DESCRIPTIVE REPORT

Type of Survey Topographic Photogrammetric  
(Multiplex)

Field No. \_\_\_\_\_ Office No. T-8641

Locality Columbia Falls, Centerville,  
Jonesboro Station

## LAYOUT SKETCH

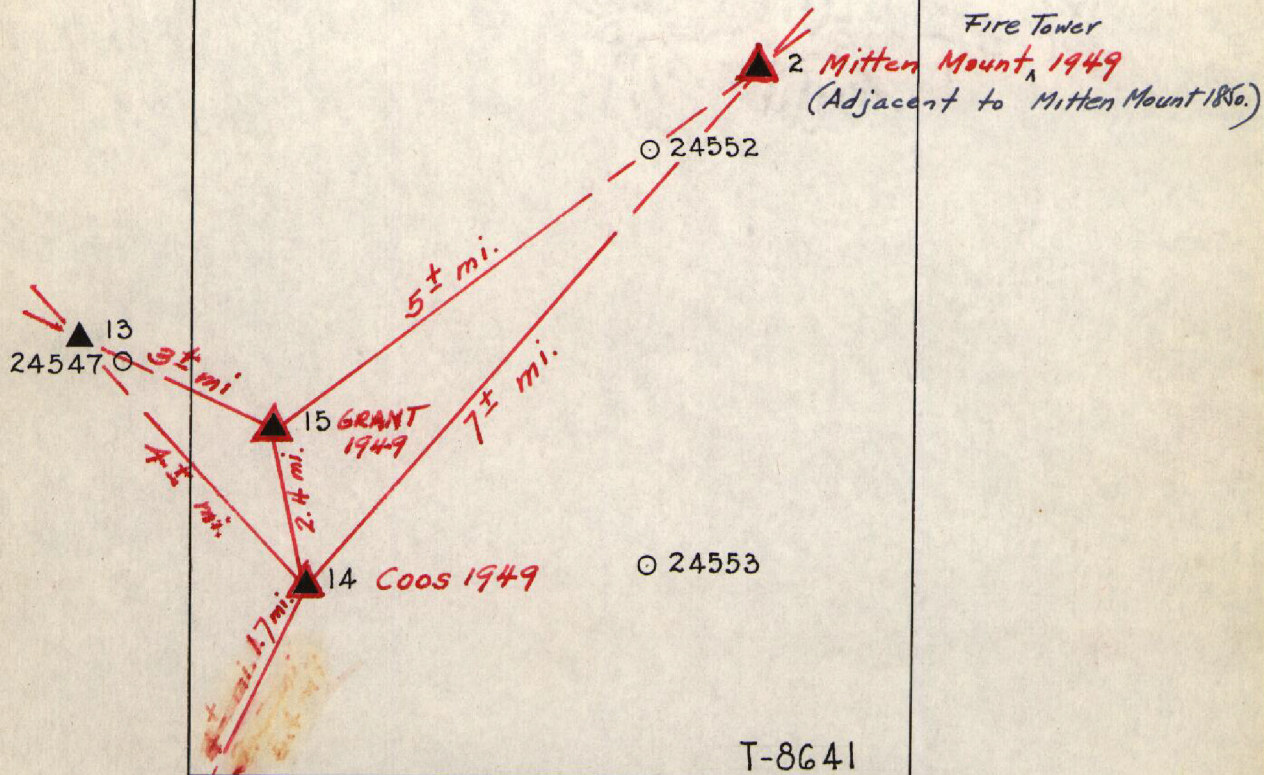
The amount and distribution of control was adequate for a satisfactory radial plot except in the northwestern part of the survey. A sketch showing distribution of control and photograph centers, and a list of control stations are attached to this report.
